ADDENDUM

Project Name:	Hamtramck Public Schools HVAC Upgrades Phase 2	Addendum No:	Two (2)
Project Number:	22-118	Issue Date:	September 21, 2022
Project Location:	Hamtramck, Michigan

To the Contract Documents for the requested: **HPS HVAC Upgrades Phase 2**

1
Lower Level Floor Plan
1/8" = 1'-0"

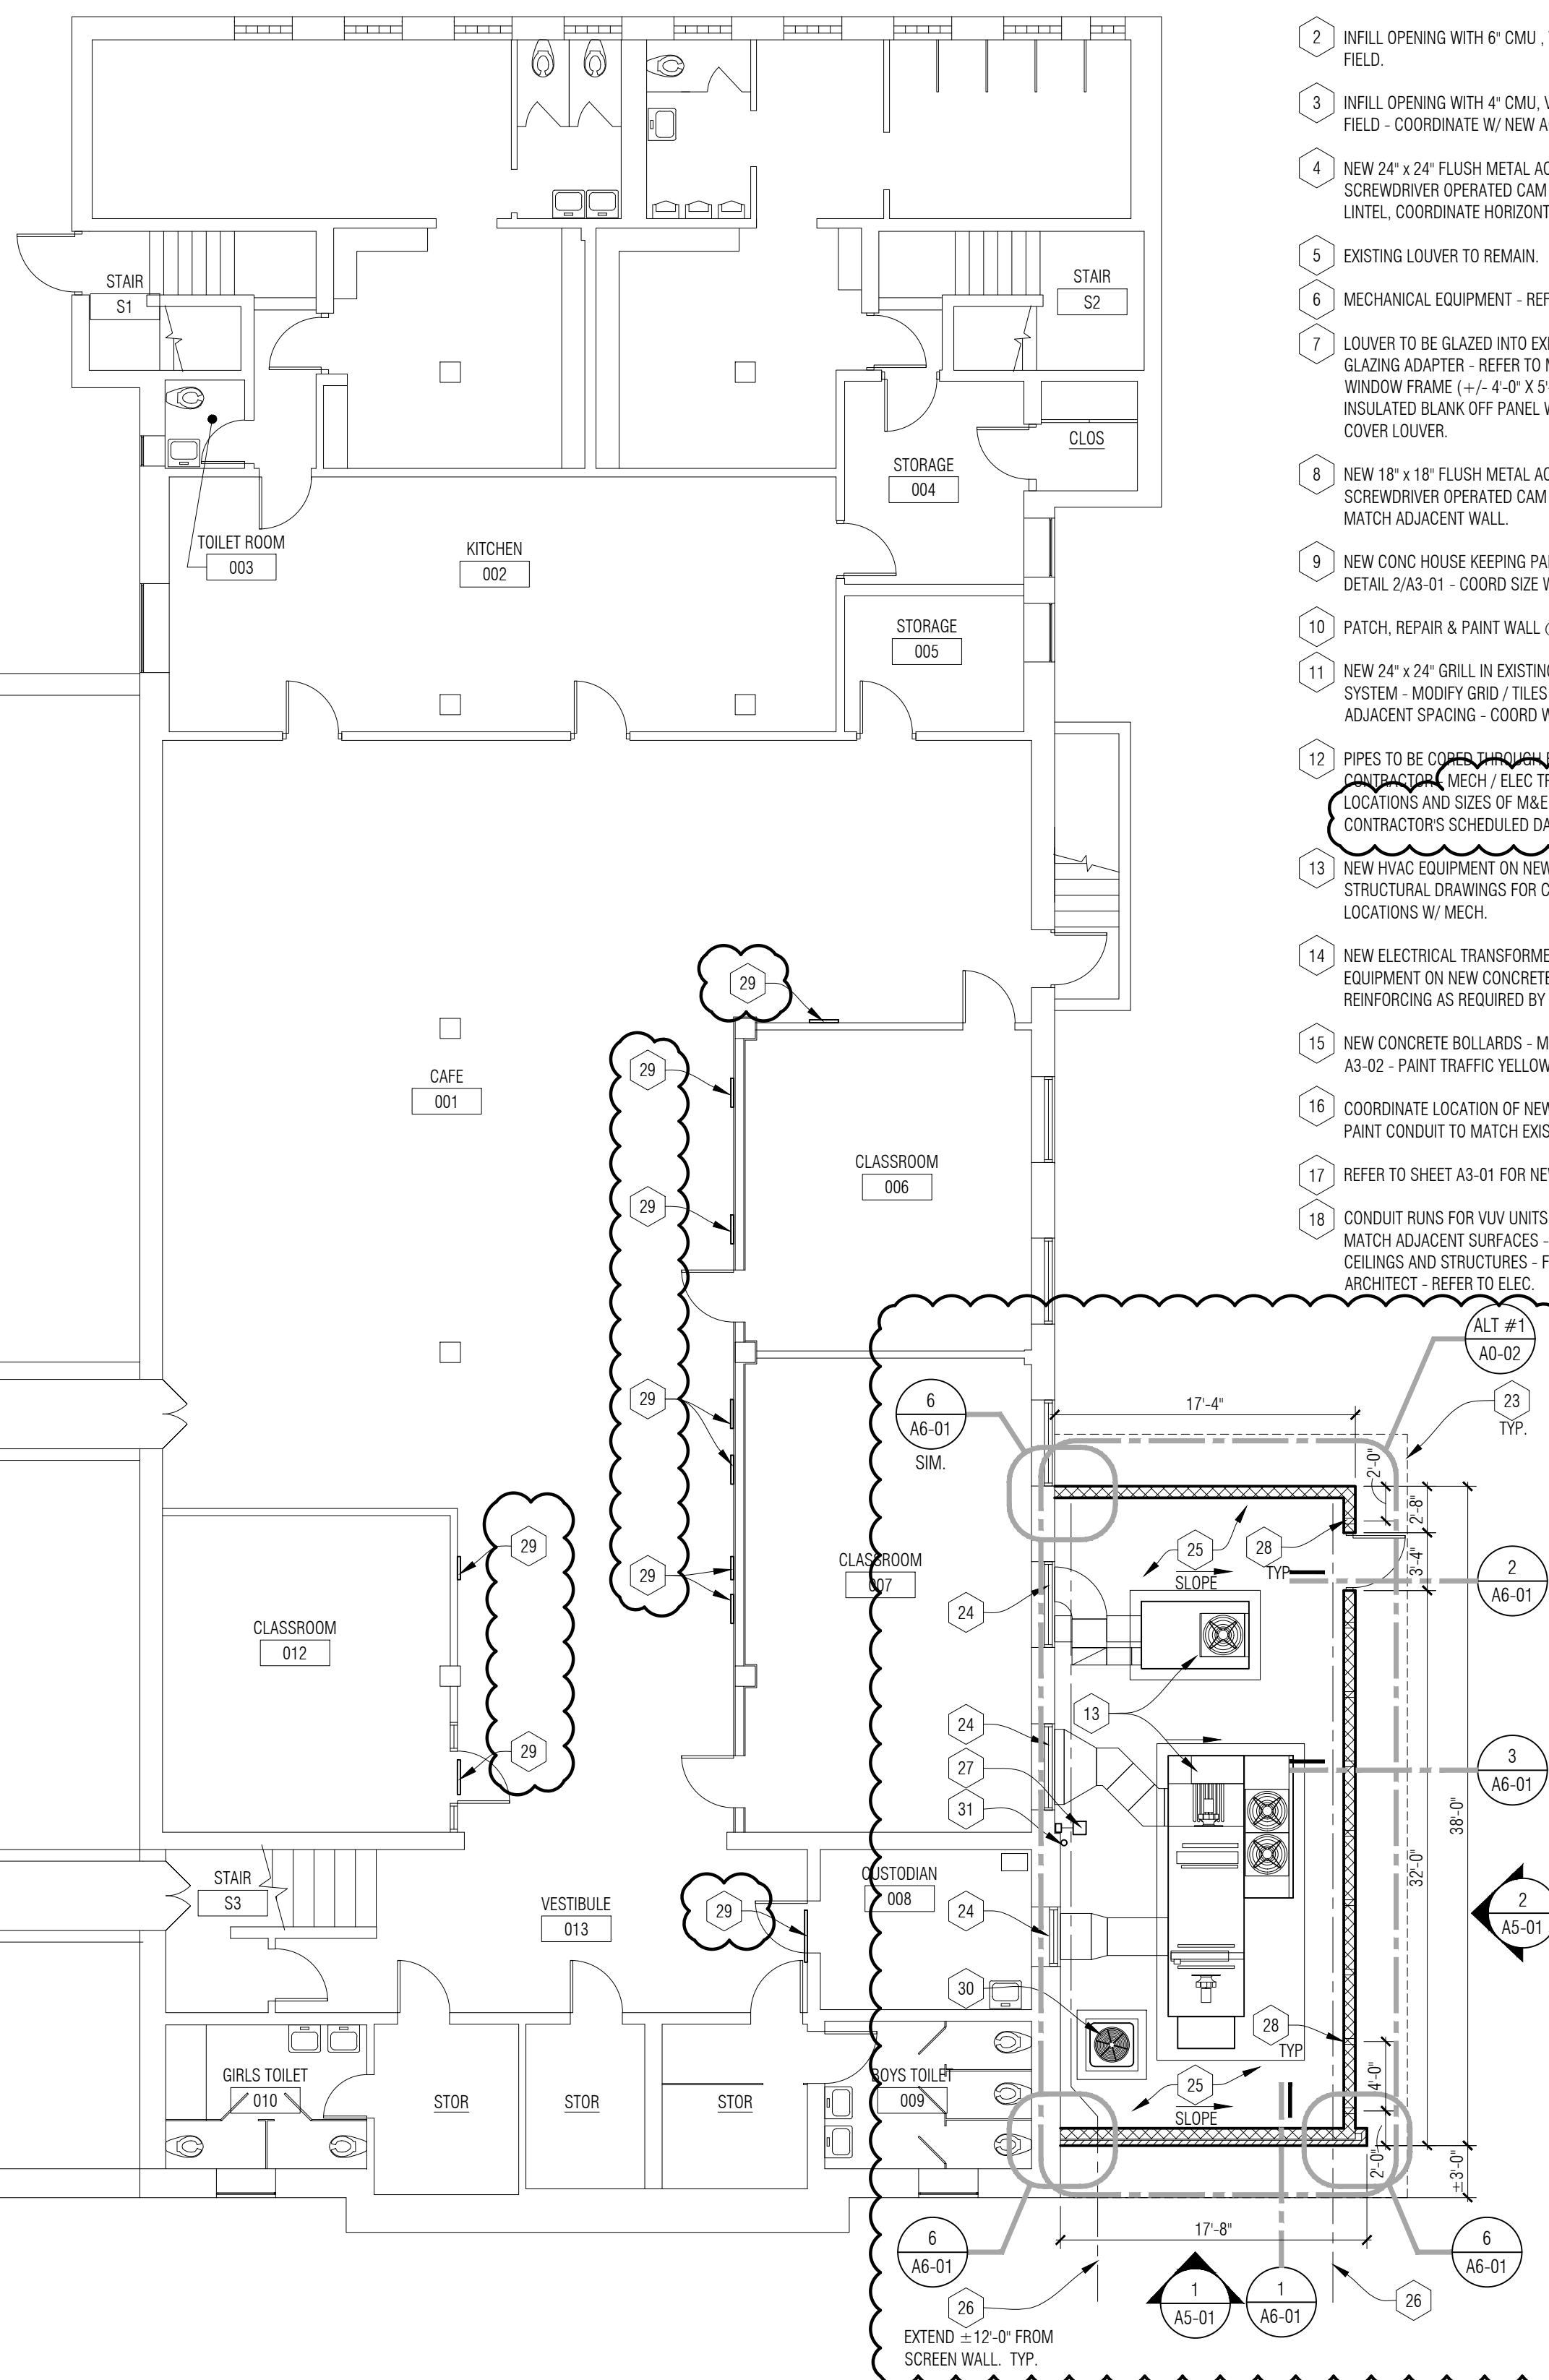
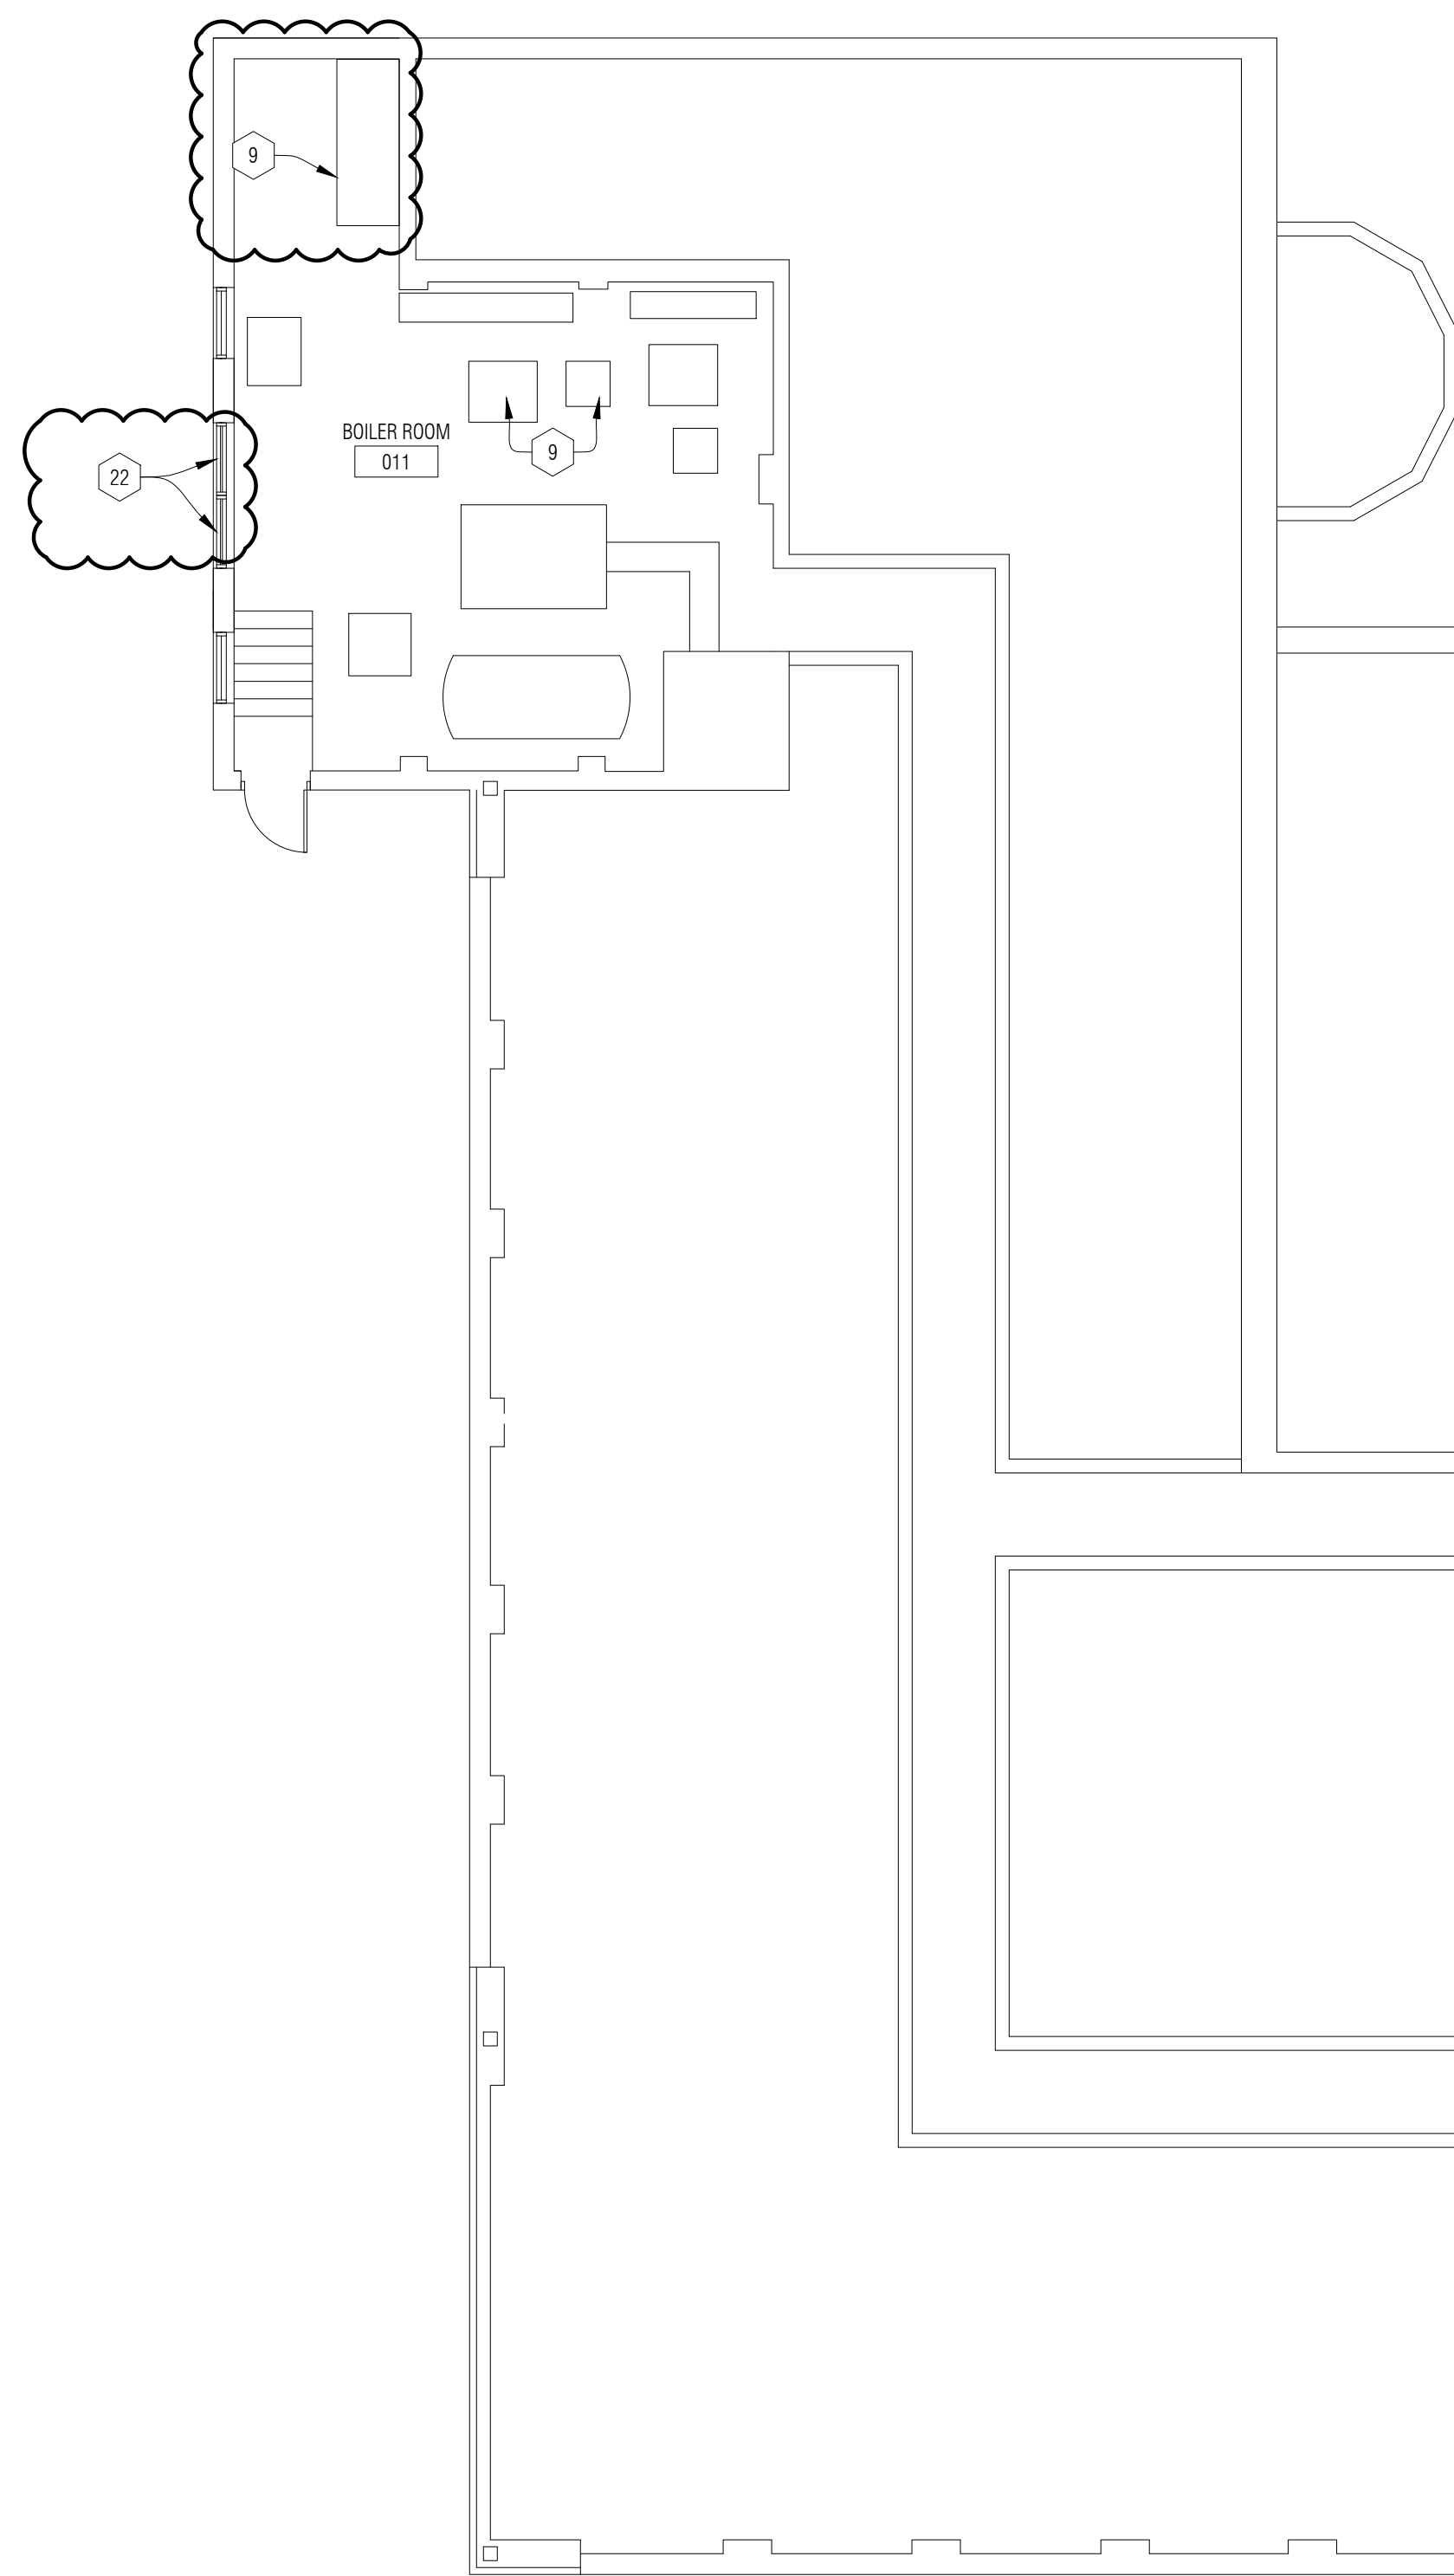
- Item A5** Drawing A3-01; LOWER LEVEL FLOOR PLAN (re-issued)
A. Scope clarification and key note update
B. New site underdrain installation
- Item A6** Drawing A3-02; GROUND LEVEL FLOOR PLAN (re-issued)

SHEET NO.
 A3-02

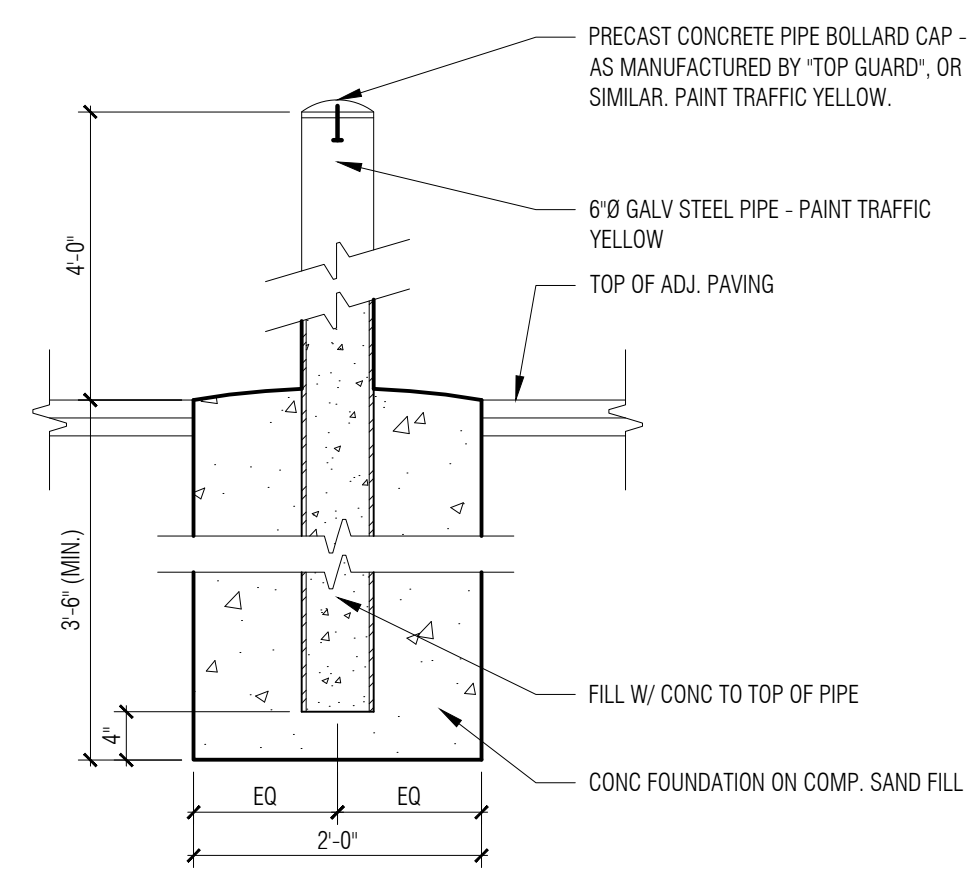
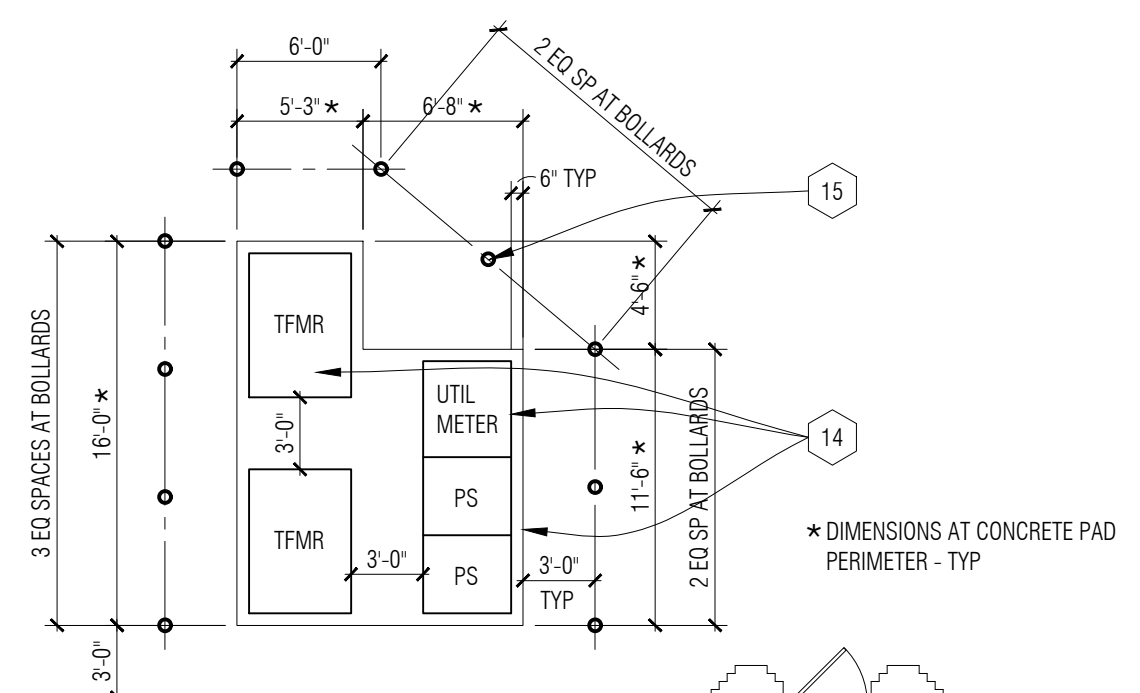
A. Scope clarification and key note update
B. Layout and utility piping coordination changes.
- Item A7** Drawing A3-03; UPPER LEVEL FLOOR PLAN (re-issued)
